ADDENDUM NO.: 3

Description: Furnish, deliver and set in place filed trailer

Project: SUNY Purchase

Drawing Title
DASNY FIELD TRAILER LOCATION PLAN AND NOTES

D1 PIER DETAIL
 SK-1 SCALE: 1/2" = 1'-0"

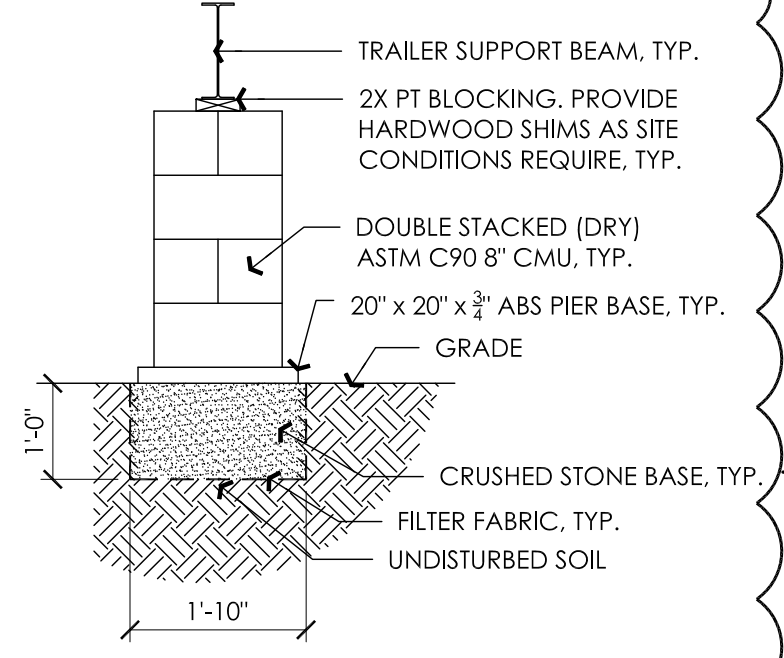
Question 7: Please confirm no below grade footings are required under bldg. or decking.

Response 7: See “General Notes” section of attached Plan Sheet SK-1.

D2 SKIRT DETAIL
 SK-1 SCALE: 1/2" = 1'-0"

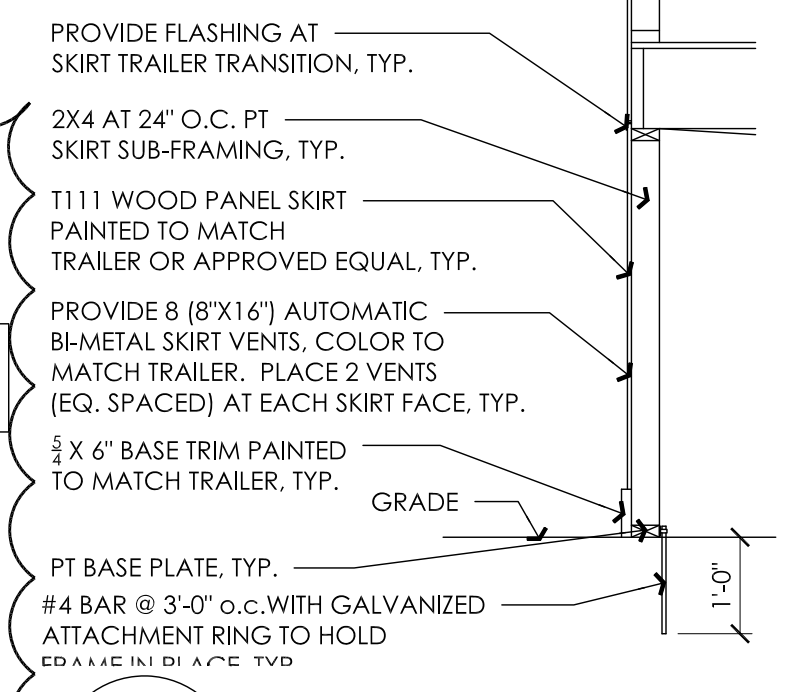
Question 16: Plan Sheet SK-1; General Notes; # 5 states to provide vinyl trailer skirt and to include (4) automatic vents. Since the vinyl skirting is designed with integrated venting is there a need for the automatic vents? If automatic vents are required please provide clarification of type and model (i.e. temperature or humidity controlled?).

Question 17: Plan Sheet SK-1; General Notes; # 7 states to provide pavers at perimeter of trailer skirt. In discussions with DASNY field representative, the concerns was the maintenance of grass and damage to the skirting. We are concerned with settling/movement of pavers which will impact integrity of skirting. Based on concerns raised by DASNY field representative we would recommend installing 2x4 PT skirt sub-framing 24" OC with a 5/4 x 6" PT Base to elevate skirting above grade and protect from maintenance of grass. Refer to attached detail for example.

Response 16: See attached Plan Sheet SK-1.

Response 17: See attached Plan Sheet SK-1.

1 24X56 MOBILE OFFICE PLAN
 SK-1 SCALE: 3/16" = 1'-0"

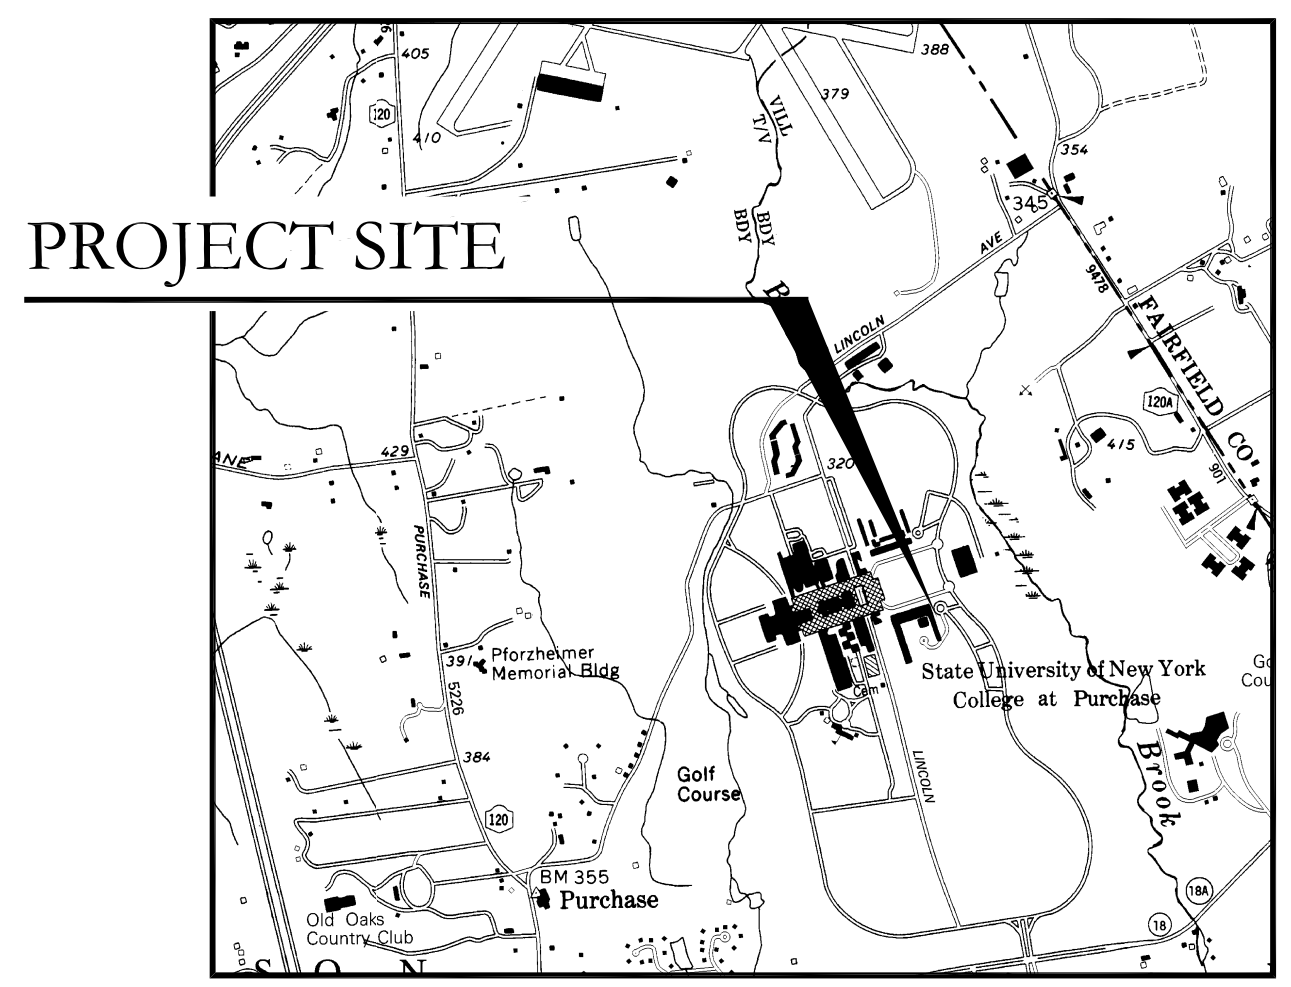
Question 13: The Floor Plan shown on Sheet SK-1 reflects a 24x60 building dimension yet the Willscot Floor Plan Sheet reflects a 24x56 building dimension. Please advise on correct building dimensions.

Response 13: See attached Plan Sheet SK-1.
